MCLEAN BLVD.

McLEAN BLVD.

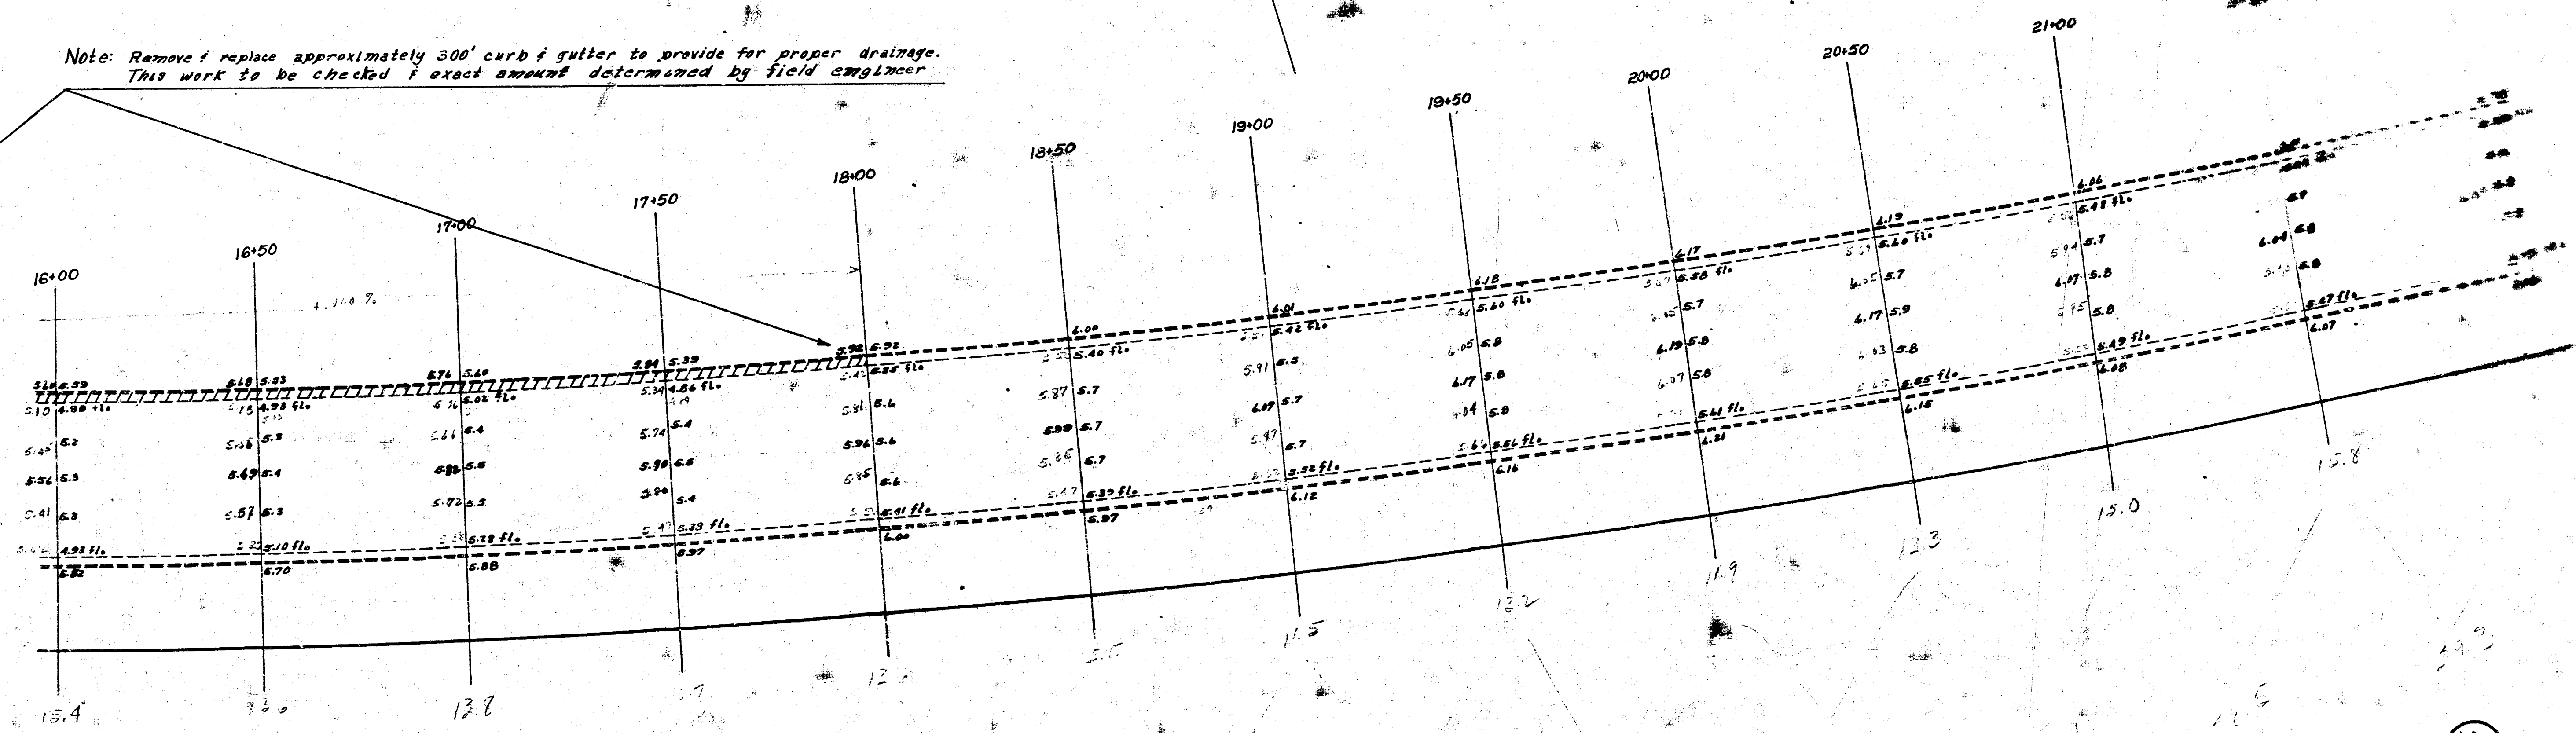
Note: Remove & replace approximately 300' curb & gutter to provide for proper drainage.
This work to be checked & exact amount determined by field engineer.

M^{LE}AN BLVD

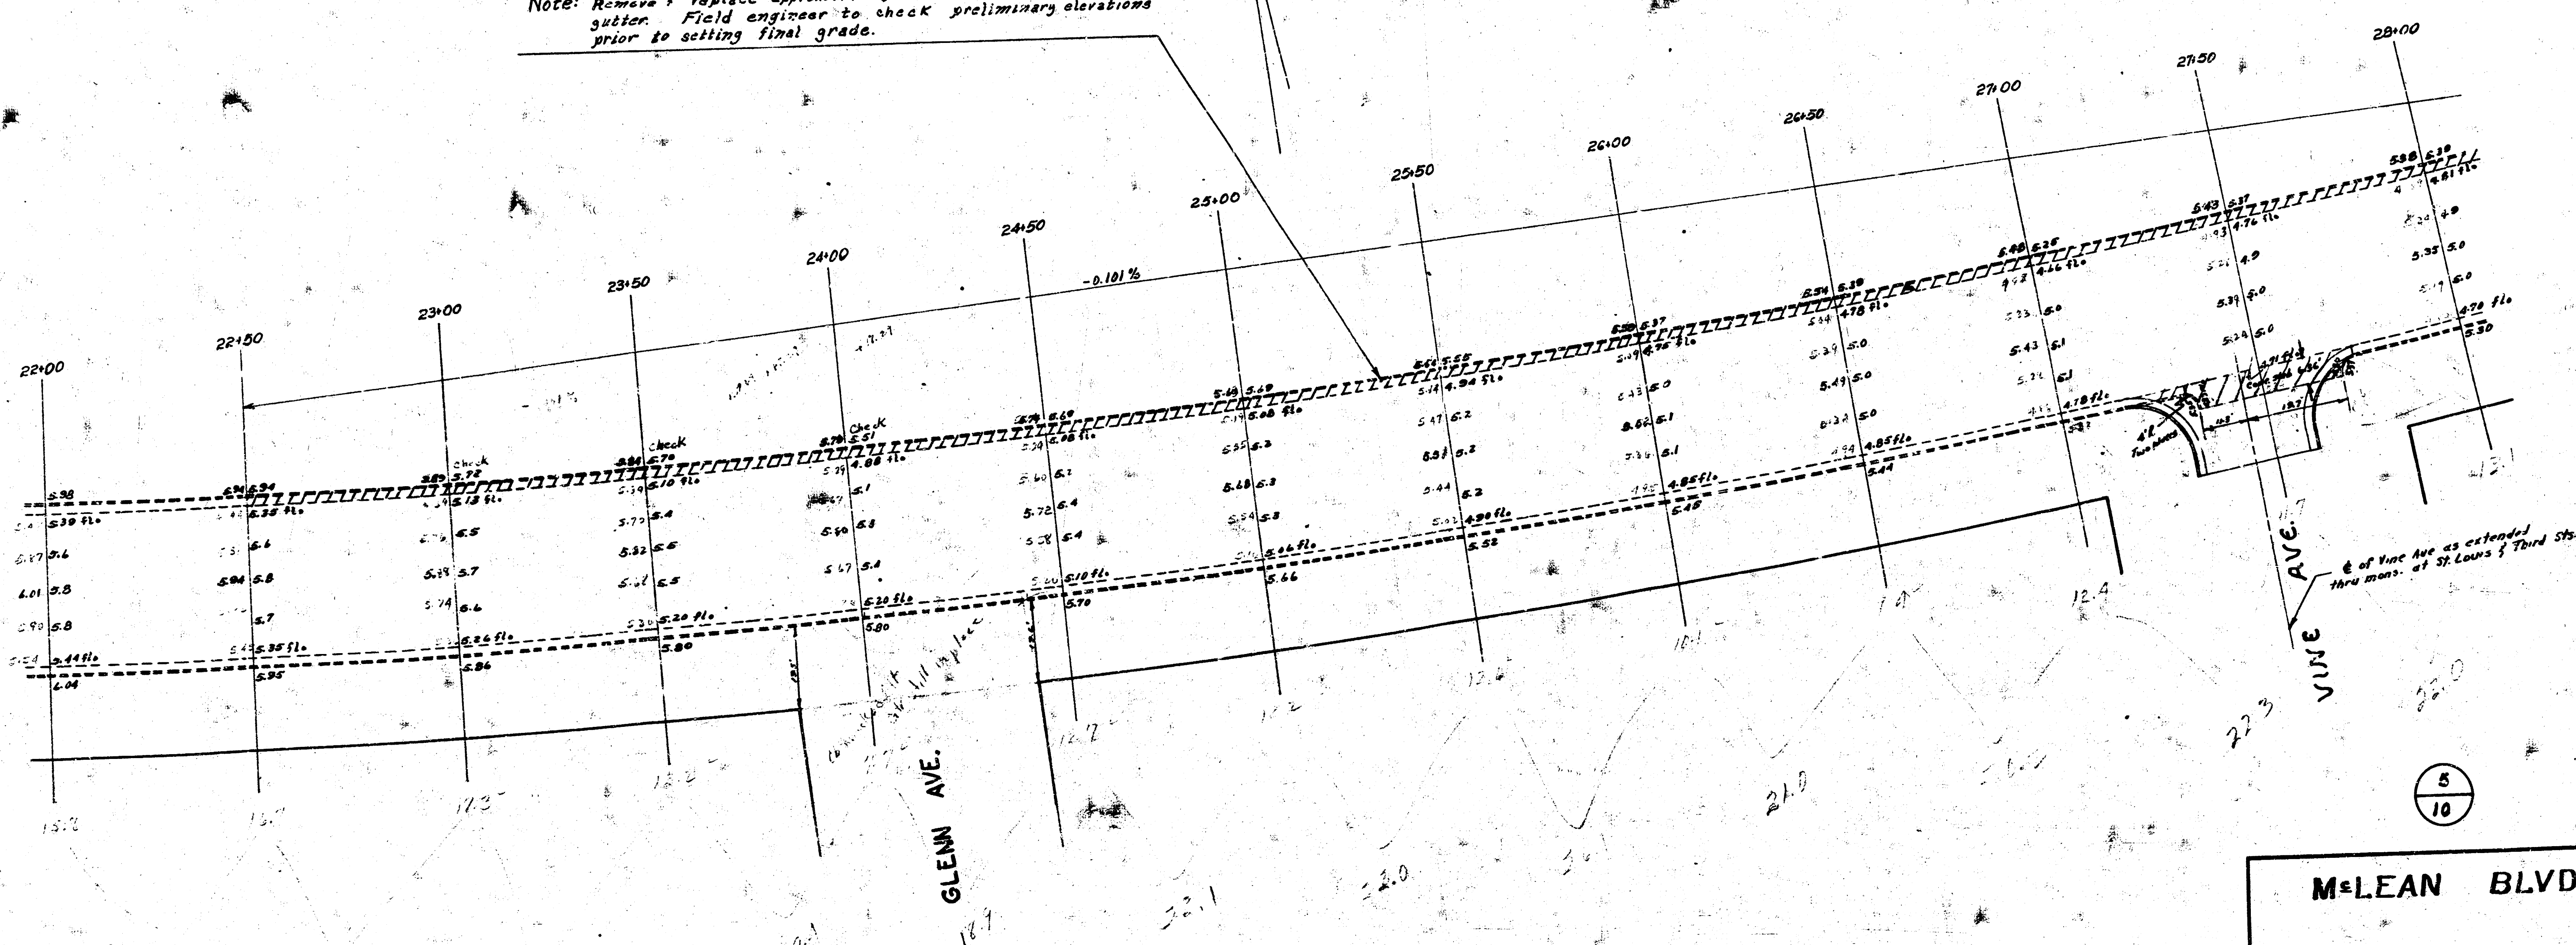
Note: Remove & replace approximately 800' (sta 22+50 to 30+50) curb & gutter. Field engineer to check preliminary elevations prior to setting final grade.
